# SCHWEIZER SERVICE BULLETIN

B-241  
10 Feb 1992

**SUBJECT: INSPECTION OF SEAT BELT SNAP HOOK END FITTINGS**

**MODELS AFFECTED:** All Model 269 Series Helicopters equipped with Davis Aircraft Products seat belts or similar seat belts.

FDA-1677-1M

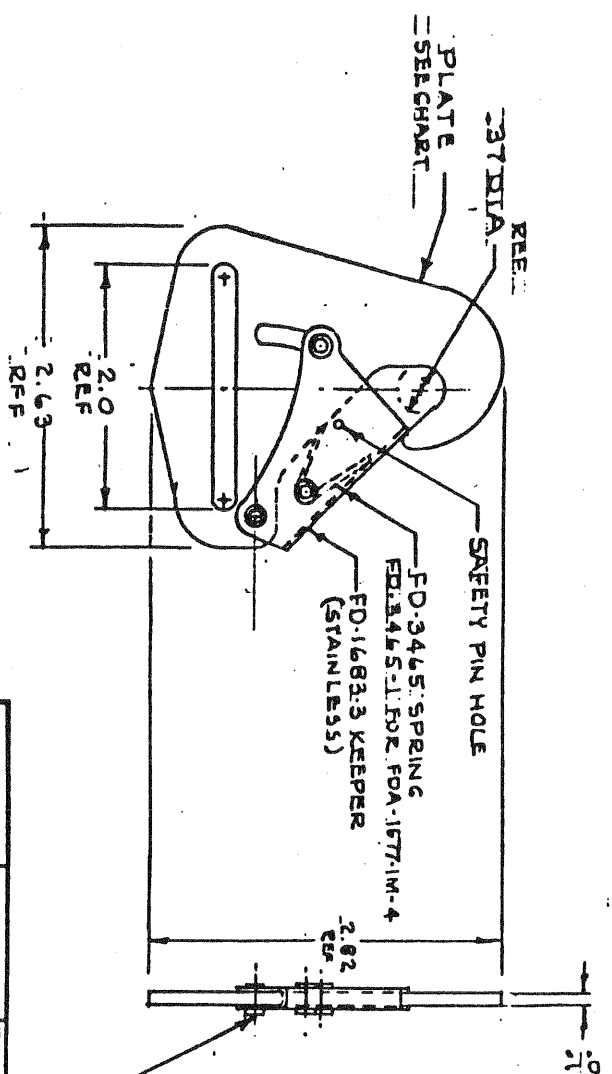
For location of safety hole refer to Davis Aircraft Products Service Bulletin No. 2, Drawings FDA-1677-1M and FDA-5576.

It is intended that hook end fittings similar to the enclosed drawings FDA-1677-1M and FDA-5576 be installed in a manner that eliminates the possibility of inadvertent or unauthorized release. Where these types of releases are possible, a safety lock hole is provided on the keeper which must be utilized by installing a cotter pin, safety wire, or equivalent which will prevent removal.

If snap hook end fitting has a safety pin hole provision, a safety device is required.

- a. Inspect seat belt snap hook end fitting for safety device.
- b. If missing, install safety device in safety pin hole.
- c. Record compliance with this Service Bulletin in the aircraft records.
